Determination 2017/060

Regarding the refusal to issue a code compliance certificate for 19-year-old additions and alterations to a house at 24 Godden Crescent, Mission Bay

Figure 1: Approximate site plan

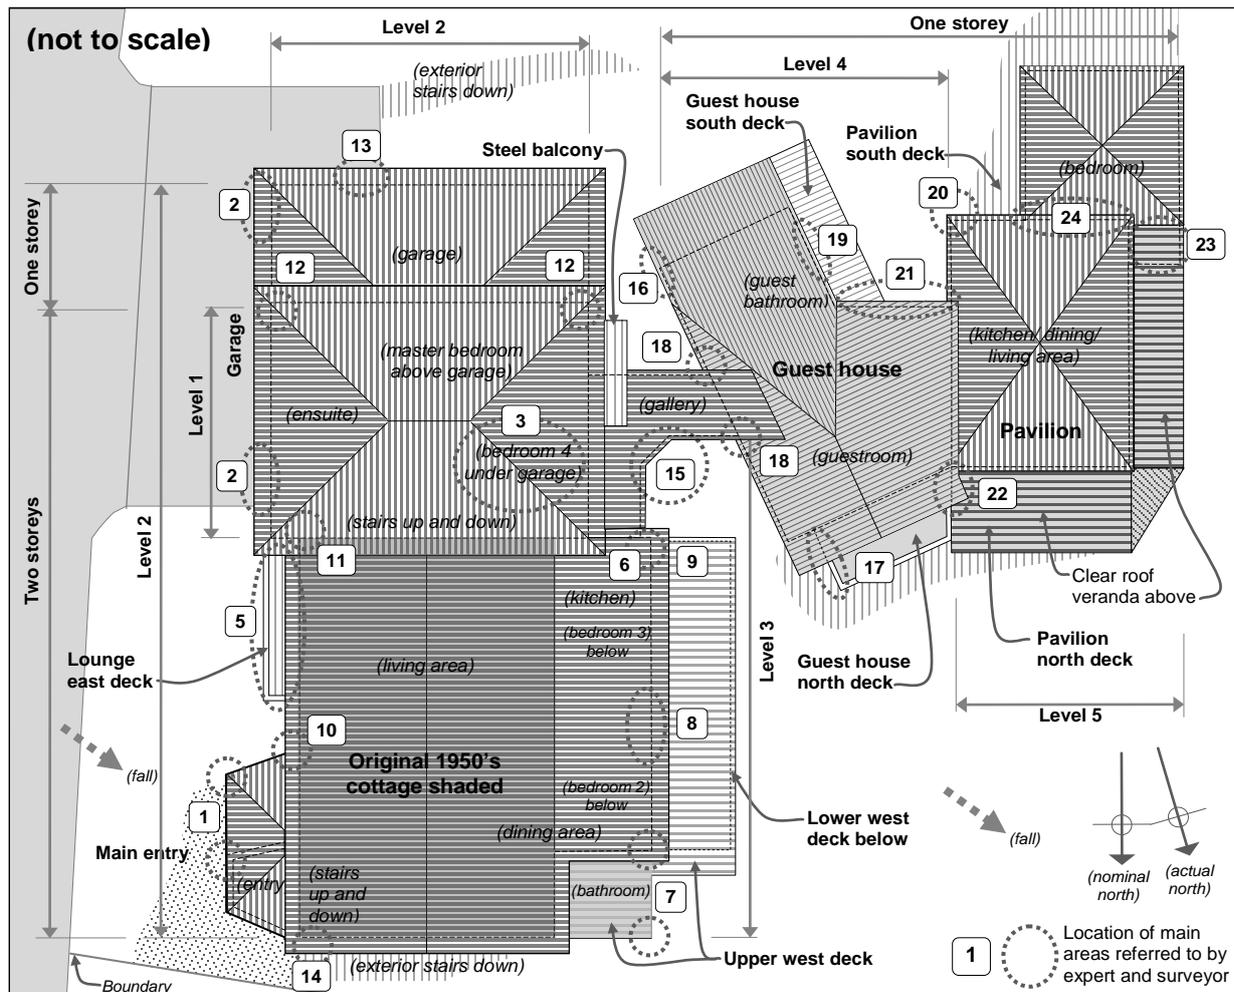
3.7.3 The report considered the areas (in summary with location references shown in Figure 1 provided in brackets)

- Bottom of apron flashing to Level 2 entry canopy (Area 10)
 - dry insulation and timber, with no evidence of historic moisture entry, 14% to 18% moisture in the native timber framing

- diverter required to bottom of apron flashing.
- Bottom of deck door to Level 2 kitchen (Area 6)
 - dry insulation and damaged building wrap, 40% moisture in bottom plate

- adjacent to exposed external corner, no sealed jamb scribes, corner flashing or cover boards
 - repairs and modification required, with Z flashing to deck stringer

- Bottom of deck door to Level 3 bedroom 2 below dining (Area 8)
 - visually dry insulation and timber, 22% moisture in bottom plate but no clear moisture source, no sealed jamb scribes

- repairs and modification required, with Z flashing to deck stringer
- Bottom of deck door to Level 3 bedroom 3 below kitchen (Area 9)
 - dry insulation and damaged building wrap, 40% moisture in top plate and top of stud

- adjacent to exposed external corner, no sealed jamb scribes, corner flashing or cover boards
 - repairs and modification required, with Z flashing to deck stringer

- Below sliding window to Level 4 guest bathroom (Area 19)
 - dry insulation, timber and wrap, no elevated moisture readings
 - no sealed jamb scribes, corner flashing or cover boards

- repairs and modification required, with sill flashing and sealant to mitres
- Bottom plates in Level 2 garage (Areas 2)
 - dry timber, 15% to 18% moisture in bottom plates

- no remedial work required.

- 5.2.4 The expert observed a section of 'H1' treated timber in the gallery subfloor and saw low levels of decay despite exposure to regular long-term wetting. He therefore considered that wall framing used in the 1996 alterations is likely to be treated.
- 5.2.5 The expert considered the localities identified in photographs and various reports and commented on their weathertightness and durability performance, while noting proposals already made within earlier reports (see Table 1). Paragraph 5.3 to paragraph 5.8 summarise the expert's comments on relevant features of the external building envelope, with localities of areas identified in Figure 1.

6.2.4 Taking account of the expert's report, I consider that the following requires attention in regard to the 23 locations shown in Figure 1 and described in this determination⁸:

- Investigation into the significance and extent of damage to the framing.
- Confirmation of the cause(s) for elevated moisture levels in some areas.
- Lack of ground clearances in some locations.
- Lack of cladding clearances to decks and steps.
- Lack of diverters to the bottom of some apron flashings.
- Lack of weathertightness to some joinery perimeters.
- Gaps to some horizontal construction joints.
- Cover battens to external corners and some other areas.
- Incomplete roof flashings and gutters.
- The lack of spreaders from upper roofs.
